Task Force on Harbourfront Developments in Kowloon, Tsuen Wan and Kwai Tsing

TFK/03/2011

Lei Yue Mun Waterfront Enhancement Project

Lei Yue Mun Waterfront Enhancement Project**Additional Information for the HC Task Force on Harbourfront Developments in Kowloon, Tsuen Wan and Kwai Tsing**

Oyster Shell Beach and Proposed Zone of
"Coastal Protection Area"

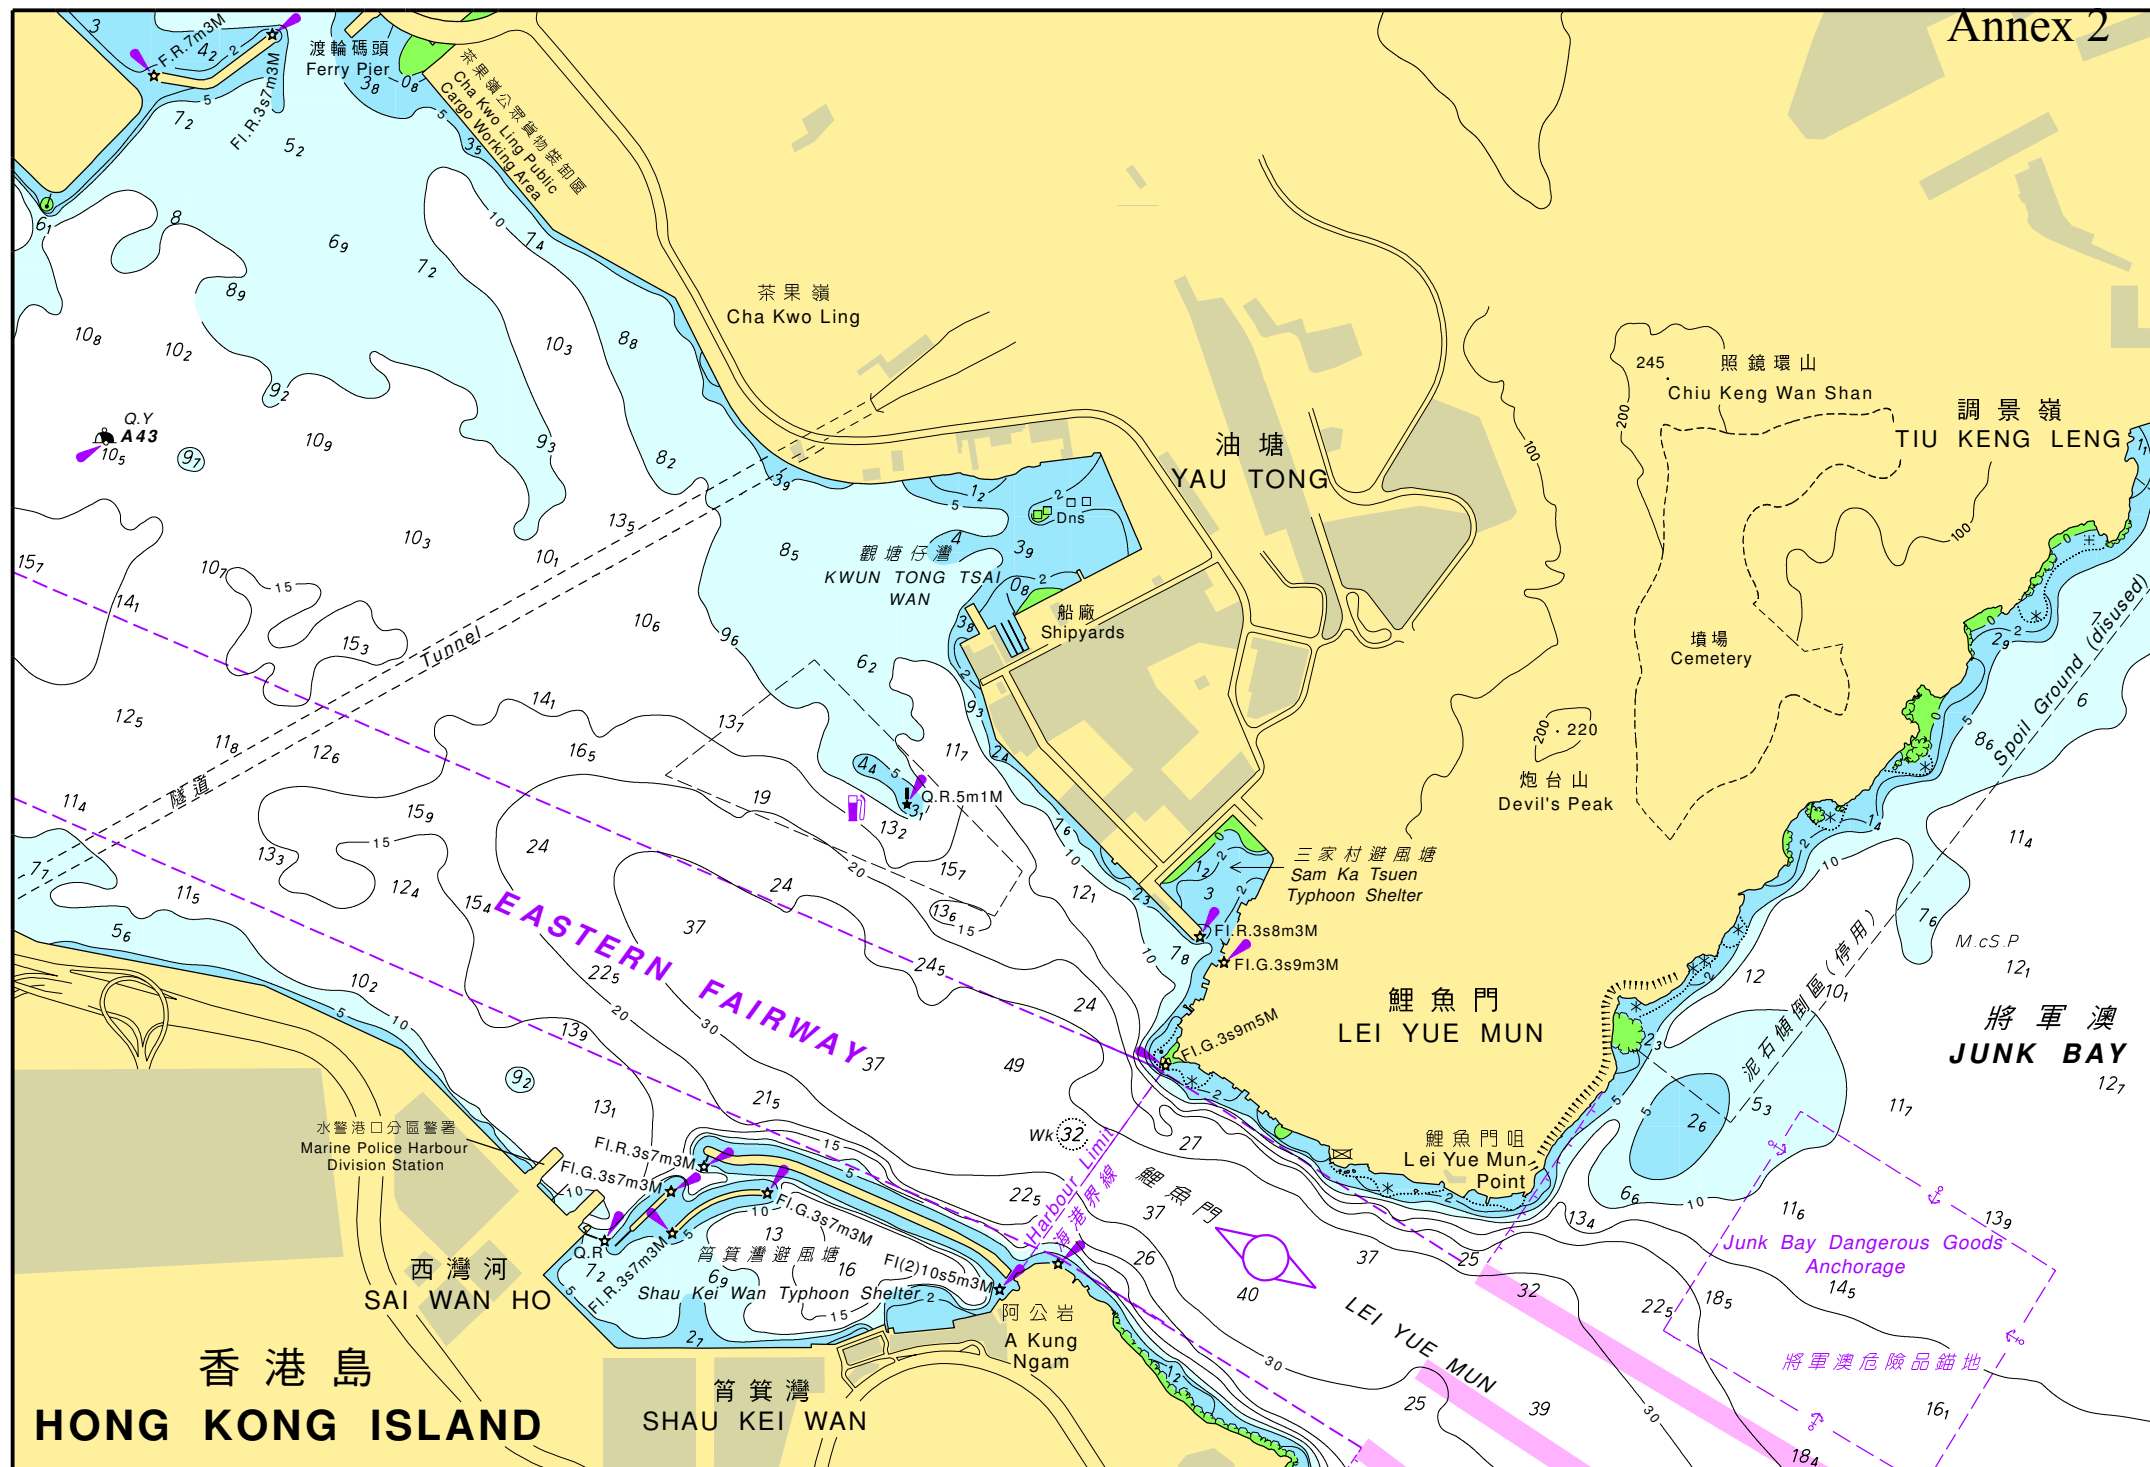
Information requested by the HC Task Force	<u>TC's response</u>
VI. <u>Other requested information</u>	
<ul style="list-style-type: none"> Details of the study supporting the visitor projection from 3,000 to 8,000. 	<ul style="list-style-type: none"> The projection, which is undertaken by HKTB, is based on tour operators' business forecast and future boat carrying capacity known to them.
<ul style="list-style-type: none"> Location of the dangerous rocks (mentioned by TC) which prohibit enjoyment of the waterfront and require a new promenade. 	<ul style="list-style-type: none"> Please see <u>Annex 3</u>.
<ul style="list-style-type: none"> Map showing the Oyster Shell Beach and boundary of the "Coastal Protection Area" zone, to show that the beach is protected entirely. 	<ul style="list-style-type: none"> Please see <u>Annex 3</u>. Part of the Oyster Shell Beach falls within the proposed zone of "Coastal Protection Area" ("CPA"), and part of it falls within the area proposed to be zoned as "Open Space" ("O") in the draft Cha Kwo Ling, Yau Tong, Lei Yue Mun Outline Zoning Plan (the OZP) No. S/K15/18. As advised by PlanD, the planning intention of the "CPA" zone is to conserve, protect and retain the lighthouse, the natural coastlines and the sensitive coastal natural environment, and only 'lighthouse', 'nature reserve' and 'natural trails' are always permitted. The area zoned "O" is intended to facilitate the implementation of the LYM Project, particularly its proposed waterfront promenade. Within the "O" zone, only uses related to the open space development are permitted.
